UNITED STATES
NUCLEAR REGULATORY COMMISSION
WASHINGTON, D. C. 20555

ARKANSAS NUCLEAR ONE - UNIT NO. 1

AMENDMENT TO FACILITY OPERATING LICENSE

Amendment No. 30
License No. DPR-51

FIGURE
6.2-1

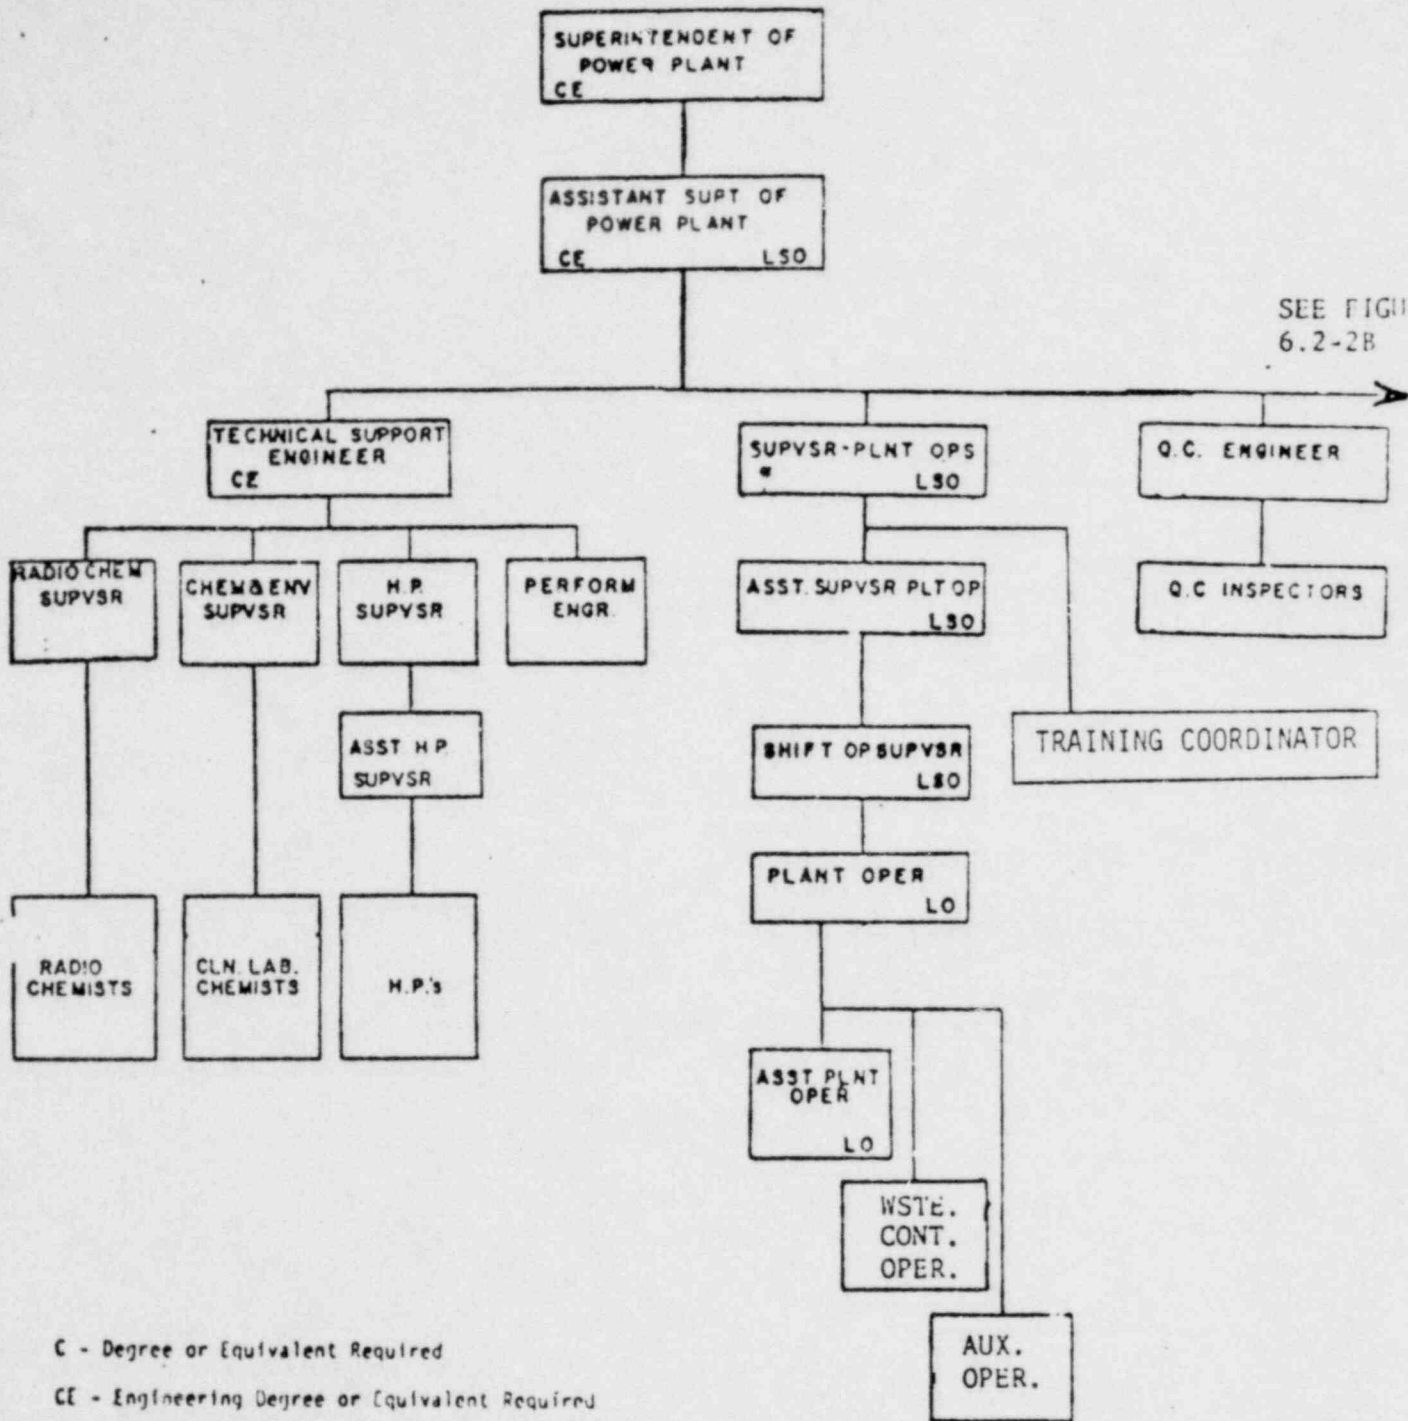
*CORPORATE RESPONSIBILITY FOR FIRE PROTECTION PROGRAM

*ONSITE RESPONSIBILITY FOR FIRE PROTECTION PROGRAM
